Access Compliance Report

Public Rights-of-Way

(Curb Ramps)

Intersection ID: 43674	Main Street: ARMOUR RIDGE DR	Cross Street: ASHETON CREEK DR	Location: W
ADA ID: 5FC110F42123	Ramp Type: Perp	Initial Pass/Fail: Fail	Overall Compliance: No
Severity Score: 21.25			
Codes/Mitigation Info/Possible Solution		Field Measurements/Component Compliance

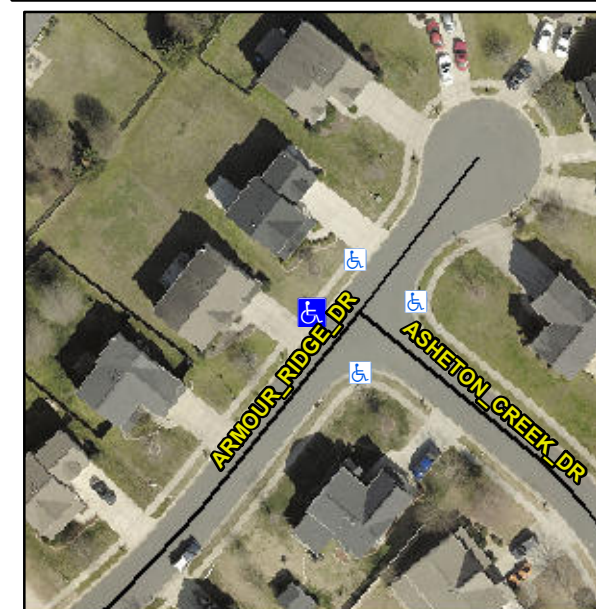
Not Found, R304.5.1, R304.2.2

Compliance	Description	Data	Compliance	Description	Data
N/A	Ramp Length (in)	47.0	No	Ramp Slope (%)	9.0
No	Ramp Width (in)	46.0	Yes	Ramp XSlope (%)	1.6
N/A	Flare Type LT	N/A	N/A	Flare Type RT	N/A
N/A	Flare Slope LT (%)	N/A	N/A	Flare Slope RT (%)	N/A
N/A	Flare Traversable LT?	N/A	N/A	Flare Traversable RT?	N/A
N/A	Landing Length (in)	N/A	N/A	DWS Provided?	N/A
N/A	Landing Width (in)	N/A	N/A	DWS Contrast?	N/A
N/A	Landing Slope (%)	N/A	N/A	DWS Length (in)	N/A
N/A	Landing X Slope (%)	N/A	N/A	DWS Full Width?	N/A
N/A	Landing Curb? (Y/N)	N/A	N/A	DWS Offset (in)	N/A
N/A	Shared Landing?	N/A			
N/A	Gutter Ponding?	N/A	N/A	Gutter Slope (%)	N/A
N/A	Gutter Lip Ht (in)	N/A	N/A	Gutter X Slope (%)	N/A
N/A	Painted X Walk1?	No	N/A	Painted X Walk2?	N/A
	X Walk 1 Direction	To SE		X Walk 2 Direction	N/A
N/A	X Walk 1 Width (in)	N/A	N/A	X Walk 2 Width (in)	N/A
	X Walk 1 Slope (%)	4.0		X Walk 2 Slope (%)	N/A
	X Walk 1 X Slope (%)	1.3		X Walk 2 X Slope (%)	N/A

Remove & Replace Entire Ramp.
